#### **ALERT SERVICE BULLETIN**

**427-21-44** 15 February 2021 Revision A, 6 April 2021

SUBJECT: TRANSMISSION OIL CHECK VALVE 209-062-520-001, INSPECTION AND REPLACEMENT OF.

Figure 2. Transmission Oil Check Valve Outside Diameter Measurement

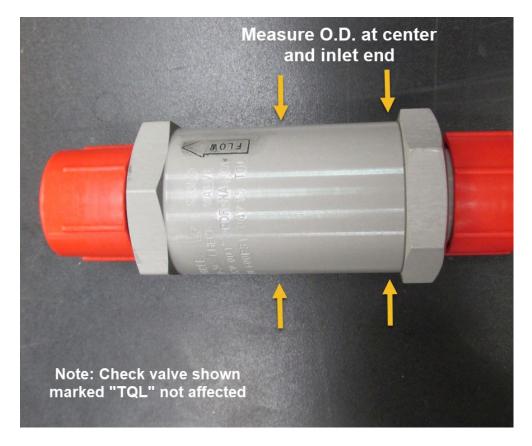
- 2. Verify if the installed check valve is affected by this bulletin.
- 3. If the check valve is <u>not</u> affected, go to step 5.
- 4. If the check valve <u>is</u> affected, proceed as follows:
  - a. Using a caliper or equivalent, measure the check valve housing at the center and record the dimension (Figure 2).
  - b. Measure the housing at the inlet end where the threaded fitting is installed and record the dimension.
  - c. If the dimension measured at the inlet end is no more than 0.003 inch (0.0762 mm) greater than the measurement at the center, the valve <u>is</u> serviceable and does <u>not</u> require accomplishment of **Part II** or **Part III** of this bulletin. Go to step 5.

- d. If the dimension measured at the inlet end is greater than 0.003 inch (0.0762 mm) when compared to the measurement at the center, the valve will require replacement. **Part III** can be accomplished immediately, or **Part II** can be accomplished until the affected check valve can be replaced in accordance with **Part III**.
- e. If the defective check valve is not replaced immediately, **Part II** must be accomplished every 25 flight hours or 30 days, whichever comes first, until **Part III** is accomplished.

- 1. Prepare the helicopter for maintenance and gain access to the transmission oil check valve (Figure 1, Details A).
- 2. Using a strong light source, visually inspect the transmission oil check valve for general condition and oil leaks. Inspect for cracks at the inlet end where the threaded fitting is installed (Figure 2).

Figure 3. Cracked Oil Check Valve

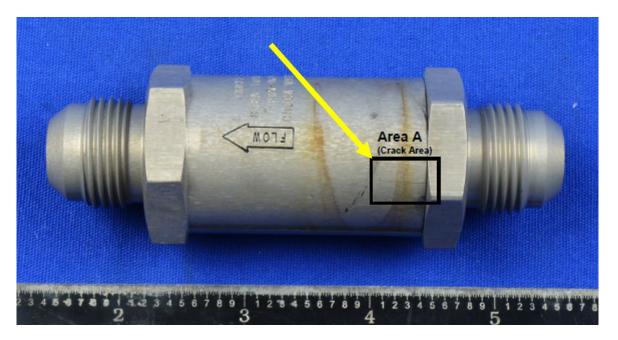
- 3. If a crack is found, perform, **Part III** of this bulletin prior to next flight. Figure 3 shows an example of a cracked check valve.
- 4. If no cracks or any other defects that would cause the check valve to be unserviceable are found, go to step 5.

- 1. Prepare the helicopter for maintenance and gain access to the transmission oil check valve (Figure 1, Detail A).
- 2. Replace the affected transmission oil check valve (BHT-427-MM, Chapter 79).
- 3. Make an entry in the helicopter logbook and historical service records indicating compliance with **Part III** of this Alert Service Bulletin.
